service bulletin

No. 96-11

Crankshaft Replacement - 45/50 (4-Stroke)

1996 Model 45/50 (4-Stroke)

Figure 1. 45/50 4-Stroke Rework Marking

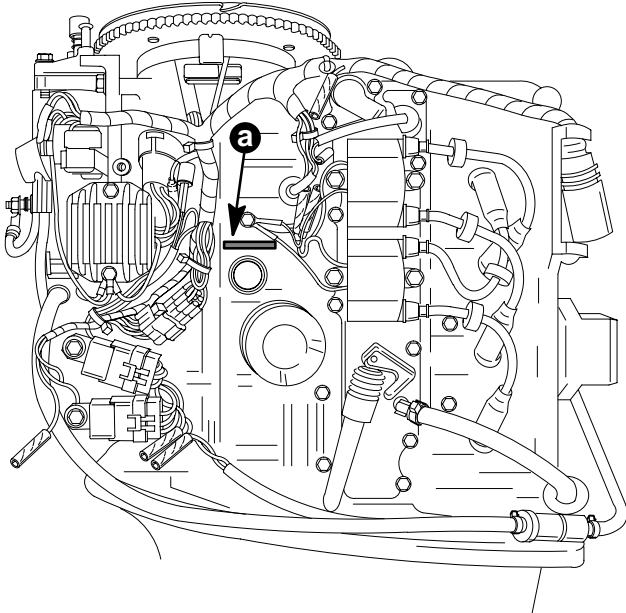
Outboards within the serial number range listed that have been reworked at the factory are identified by:

- A red dot sticker applied on the outboard serial number label of the shipping carton.
- A red dot or marking painted on the port side of the powerhead (Figure 1).

a - Red Paint Marking

Replace crankshaft assembly, upper and lower crankshaft oil seals and powerhead to adaptor plate gasket as outlined in the outboard service manual. Apply a red dot or red paint marking on repaired powerhead as shown in (Figure 1).

Replace powerhead short block assembly, cylinder head gasket and powerhead to adaptor plate gasket, as outlined in the outboard service manual. Apply a red dot or red paint marking on replacement powerhead as shown in (Figure 1).
